**HYDROLOGY STUDY  
ADDENDUM #1**

**Rainbow Car Wash**

## Drainage Study Comment Letter

RE: Technical Drainage Study for Rainbow Carwash  
PW22-10974

**FIGURE 9**  
**EXISTING CONDITION**  
**DRAINAGE BASIN MAP**

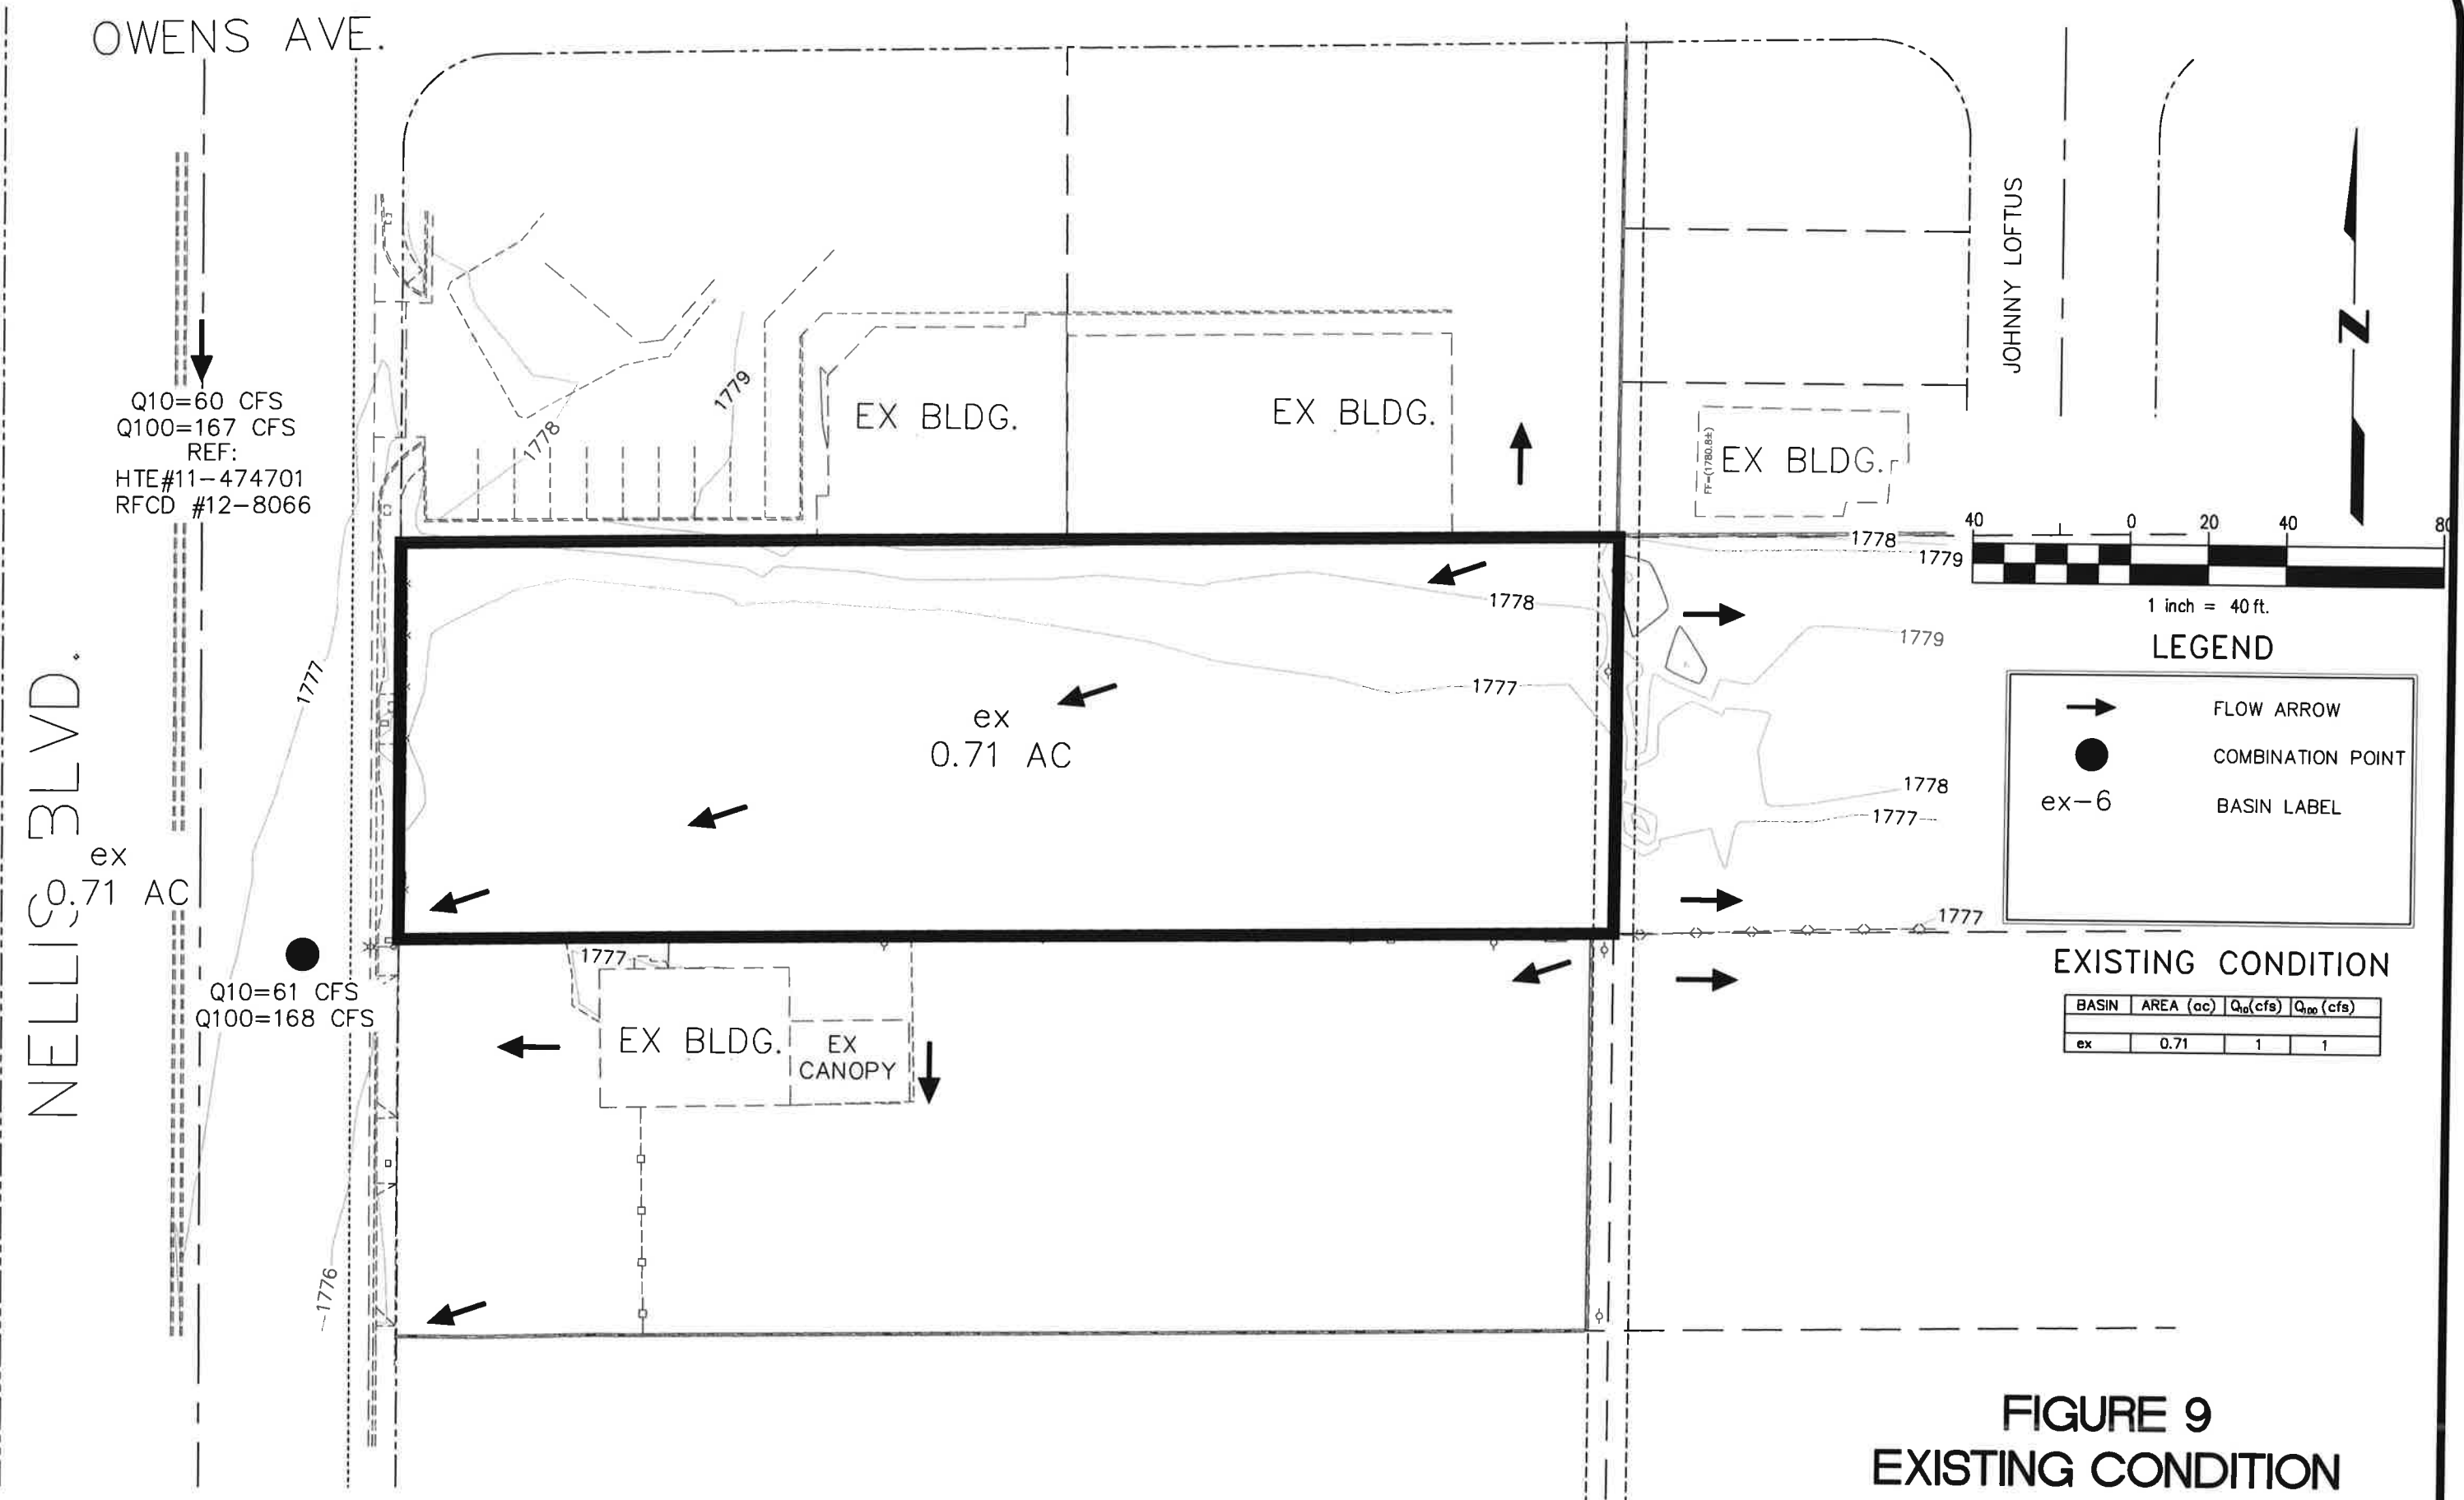
7. The figures have been redlined and attached with these comments. Review and revise accordingly. Ensure these original redlined figures are returned with the next submittal. Some items to address:

- a. Label contours on the figures.
  - b. The bar scale does not measure correctly on the printed figure. This could be a printing issue.
  - c. Add the hydraulic cross-section to the legend.

7. The figures have been redlined and attached with these comments. Review and revise accordingly. Ensure these original redlined figures are returned with the next submittal. Some items to discuss:
  - a. Label contours on the figures
  - b. The bar scale does not measure correctly on the printed figure. This could be a printing issue.
  - c. Add the hydraulic cross-section to the legend.

**Figures 9 and 10 have been revised accordingly**

- Figure 9.**            **Existing Condition  
Drainage Basin Map - REVISED**
- Figure 10.**        **Onsite Developed Condition  
Drainage Basin Map - REVISED**

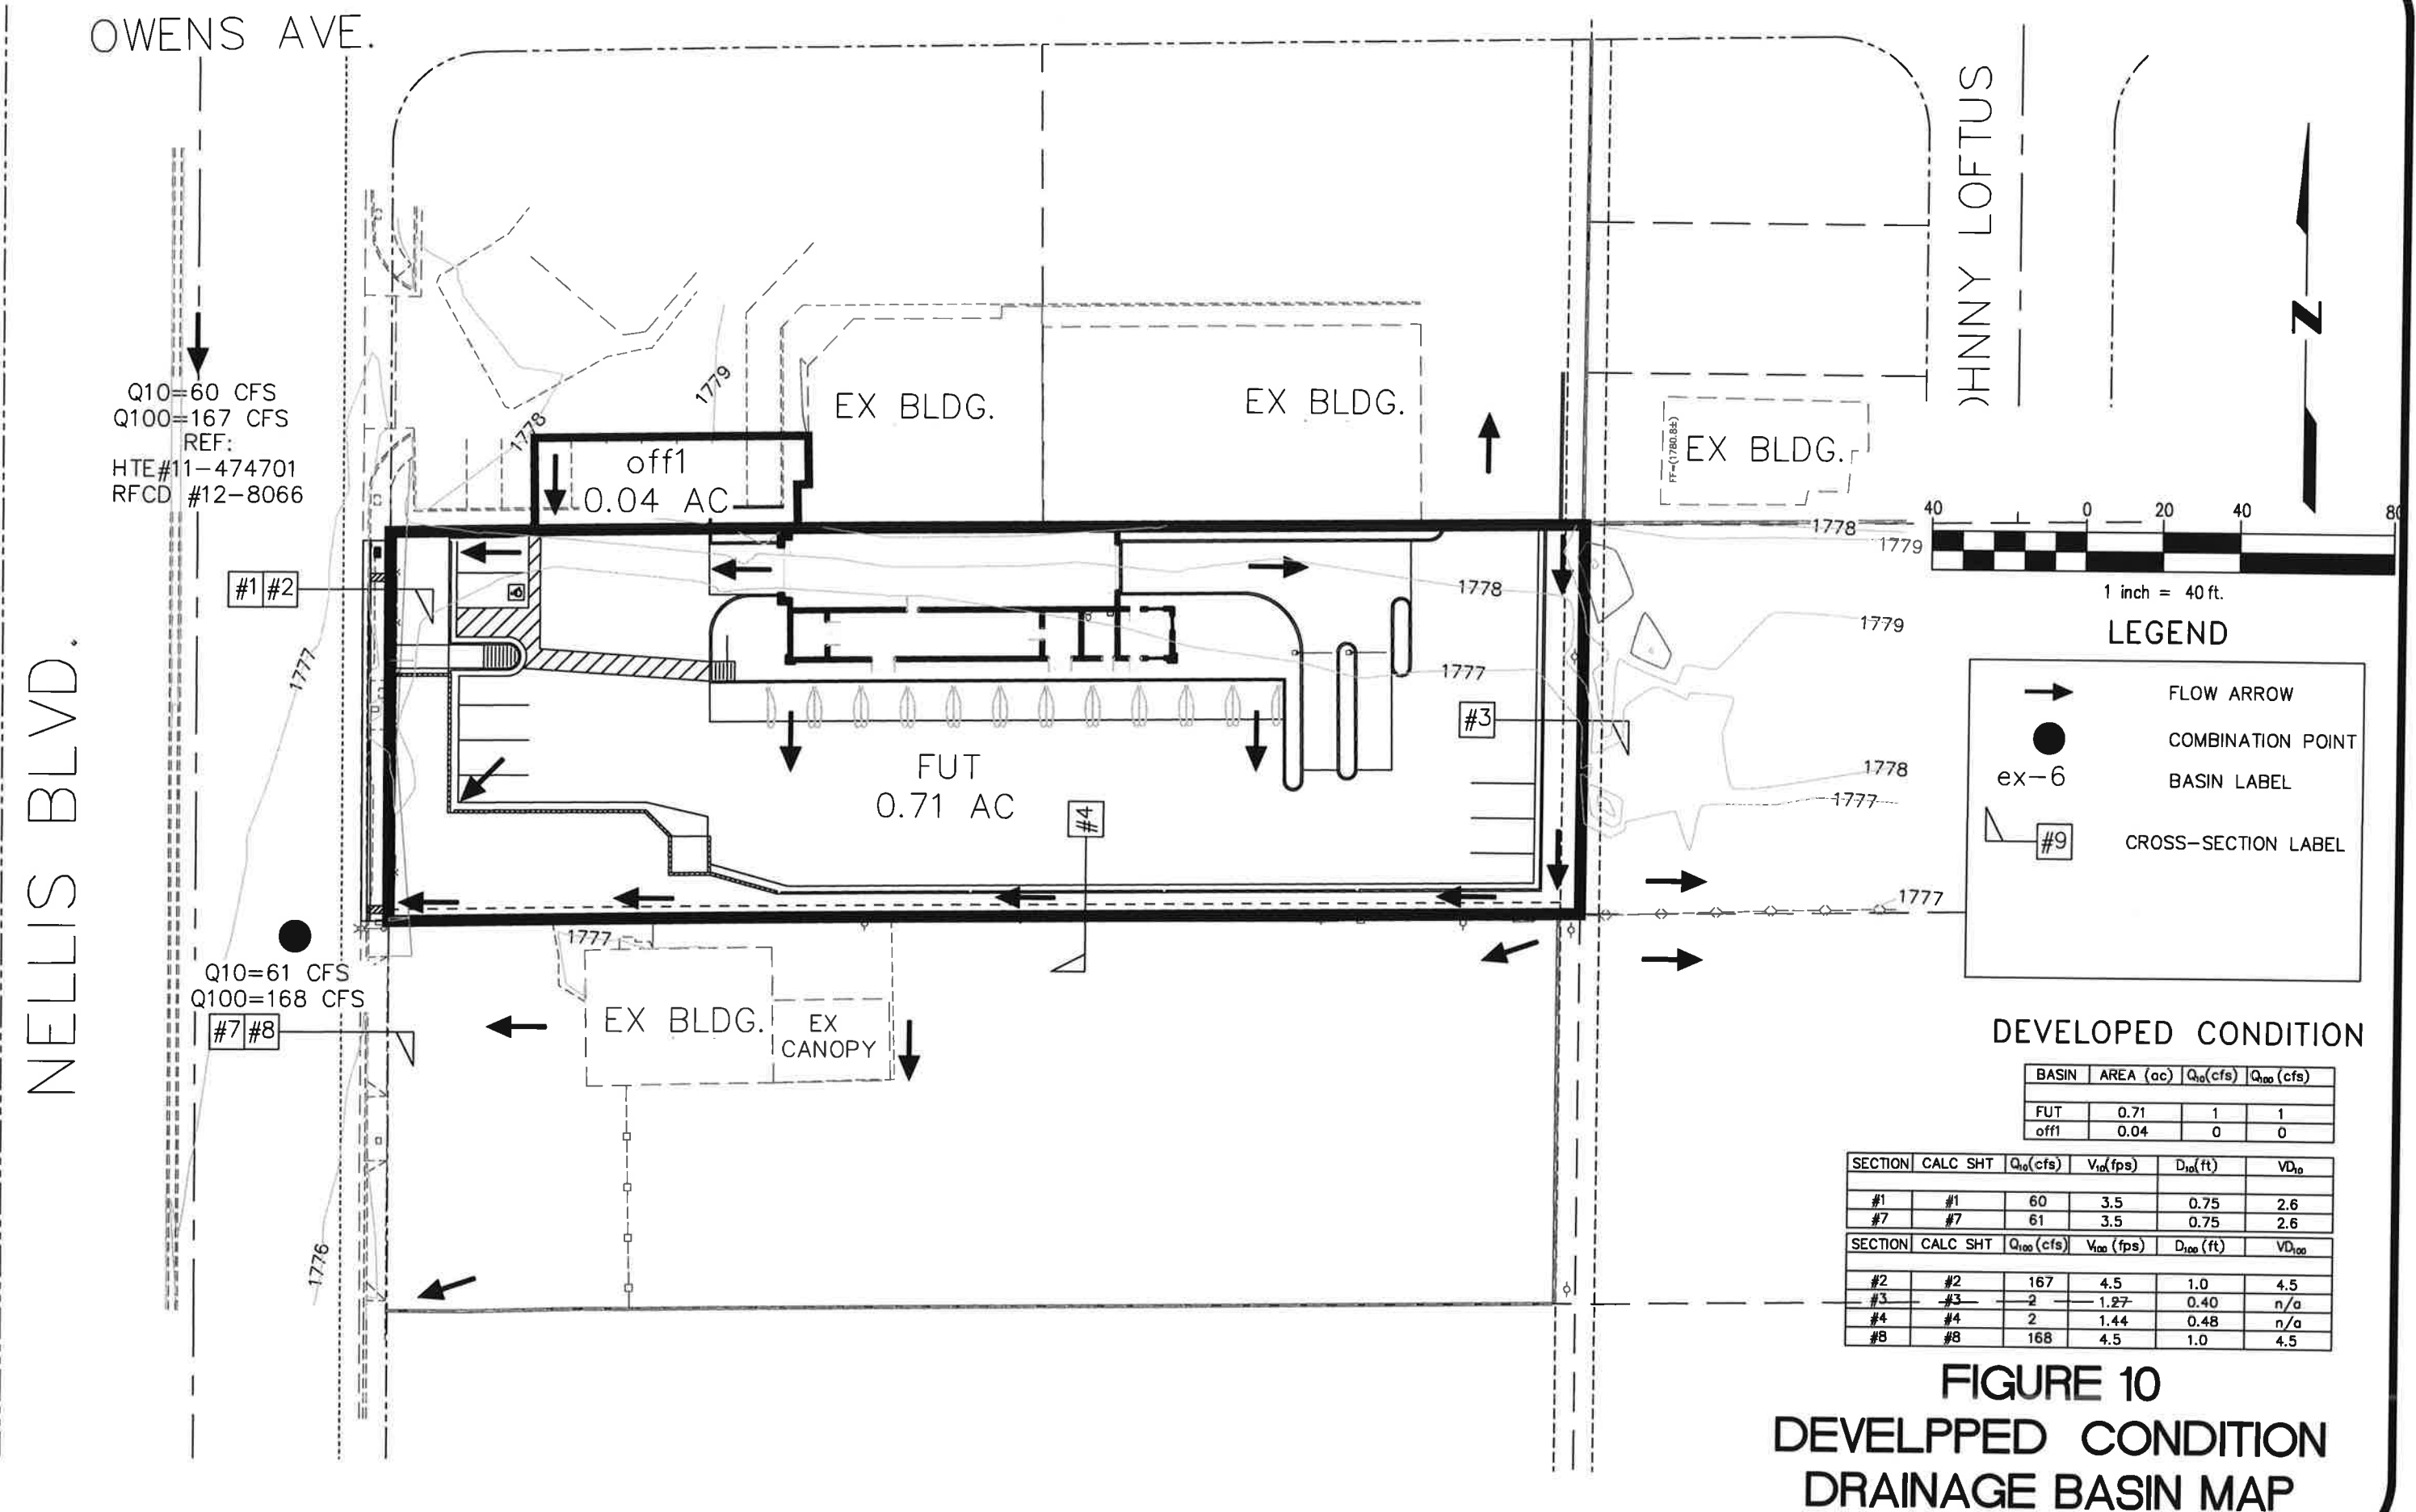
14. Per Table 4 in the reference material for study 11-44701; D100 =1.10 ft, V100 =4.76 fps, Q100 =167 cfs, Q10 =60 cfs. The values in this table for the depth and velocity do not match the values shown on the Developed Figure 10 for this study. Also, the referenced FlowMaster calculations show 166/59 cfs for the Q100/Q10 when the flows are 167 and 60. Provide the correct referenced FlowMaster 100-yr and 10-yr cross-sections for Nellis.

14. Per table 4 in the reference material for the study 11-44701; D100=1.10 ft, V100=4.76 fps, Q100=167 cfs, Q10=60 cfs. The values in this table for depth and velocity do not match the values shown on the Developed Figure 10 for this study. Also, the referenced FlowMaster calculations show 166/59 cfs for

Q100/Q10 when the flows are 167 and 60. Provide the correct referenced FlowMaster 100-yr and 10-yr cross-section for Nellis.
